Revision Description	Date	Rev. No.	Issued by
LRD Amendment Application	09-10-2026	A3-C01	MM

Project: Player Wills
Location: Former Player Wills Site, South Circular Road, Dublin 8
Client: CWTC Multi Family ICAV

Drawing Title: PW2 - Proposed Level 14 Plan
Drawing No.: 25068-OMP-PW2-14-DR-A-1014

PW2 - Proposed Level 14 Plan

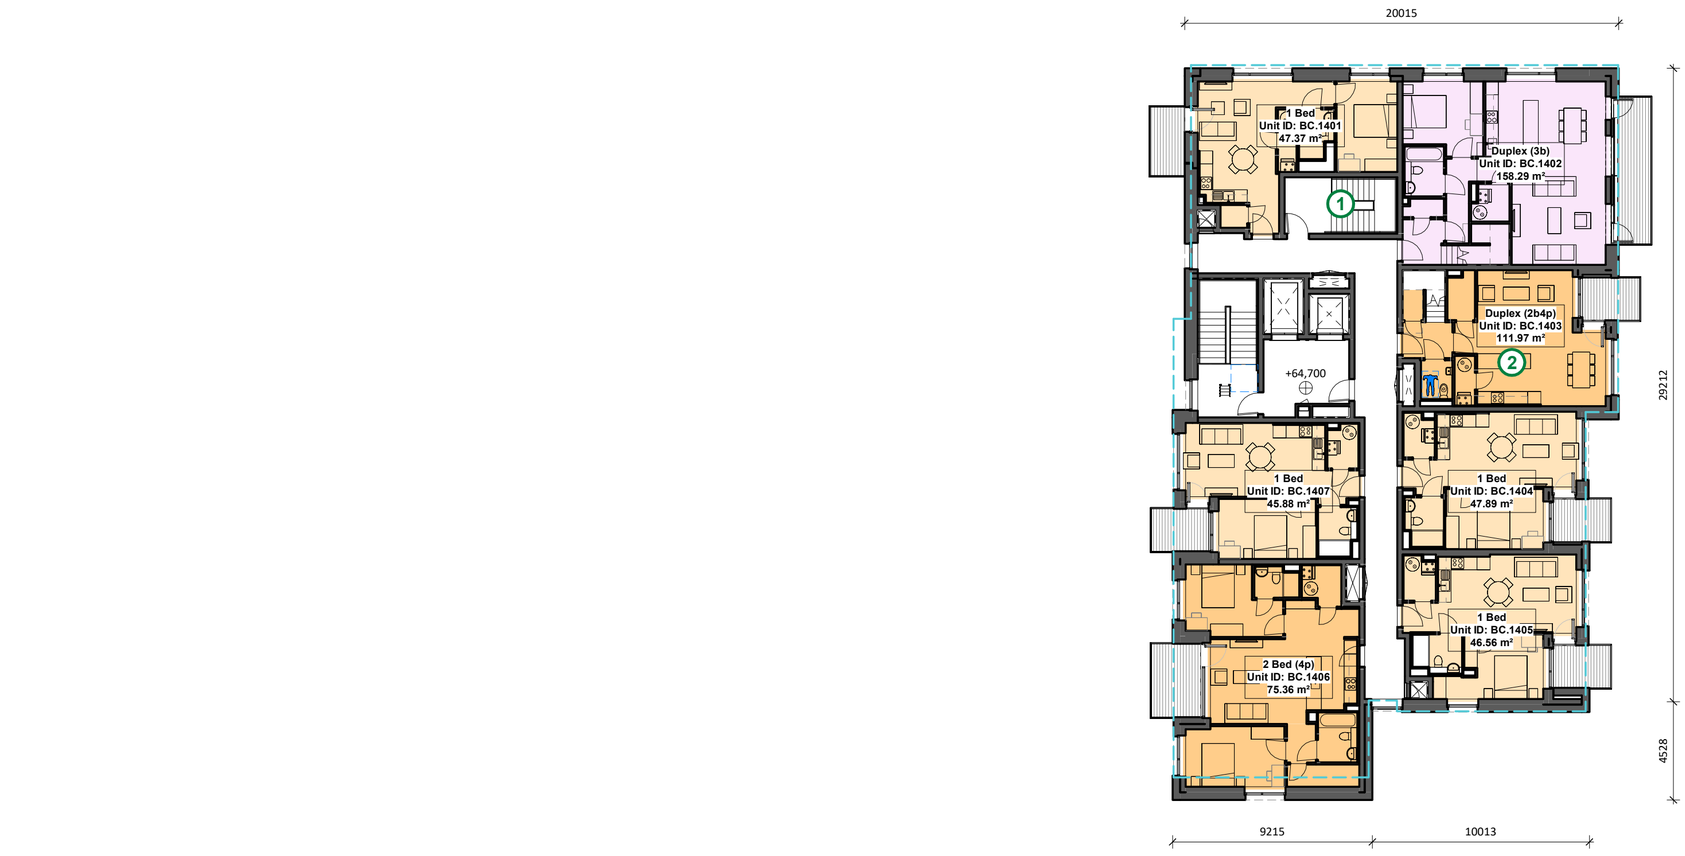
1. Provision of a second stair in accordance with updated Building Regulations (TGD Part B), with associated reconfiguration of layouts.
2. Permitted duplex unit changed from 1-bed to 2-bed
